DETAILED ACTION

Art Unit: 3745

Figure 1 Normal Operation, Single Rotor, Rated Power, Side View

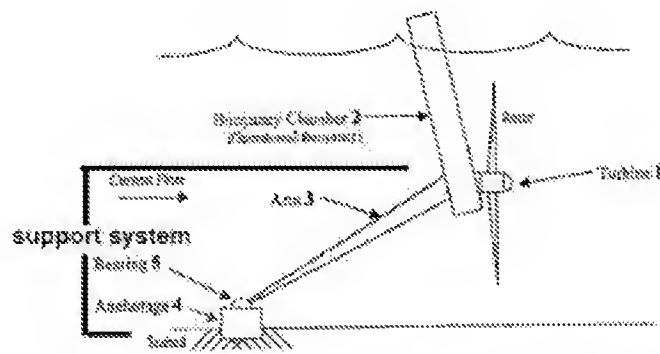
A support system for at least one water drivable turbine (1) that when in operation is immersed in a column of flowing water and is supported by a buoyancy chamber (2) (page 2, lines 5-9 and Figure 1).

A deck having an inherent buoyancy.

A support system for a water drivable turbine (61) comprising a deck (67) having an inherent buoyancy (page 4, lines 25-33, page 5, lines 8-9). It would have been obvious to one having ordinary skill in the art at the time the invention was made to modify the support system of Richard by replacing the buoyancy chamber with a deck

having an inherent buoyancy as taught by Carstens for the purpose of increasing the efficiency of the water turbine by directing the flow of water toward the turbines.

Fig. 1

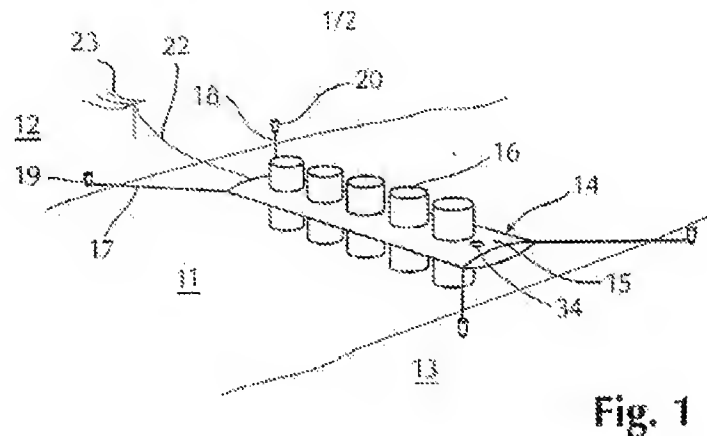
The support system of claims 1 or 2 wherein the deck has a rectangular cross section in a horizontal plane (Figure 1 of Carstens – character 15 is the deck).

The support system of claim 3 wherein the deck has a planar smooth surface of approximately rectangular form when viewed from above (see rejection of claim 3).

**Fig. 6**In Reference to Claim 19

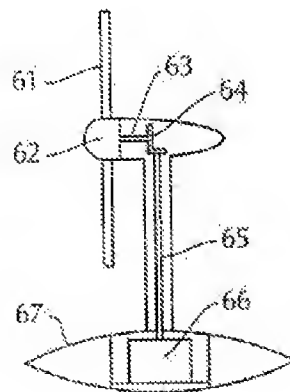
The support system of claim 7 wherein the deck is of streamlined cross section and has a convex upper (Examiner assumes surface) (page 2, lines 24-26 of Carstens).

The support system of claim 7 wherein the deck is profiled to reduce water flow velocity shear which would reduce turbulent flow, reduce fatigue loads, and enhance efficiency. The profile of the deck as shown in Figure 6 of Carstens would inherently perform the limitations of claim 14.
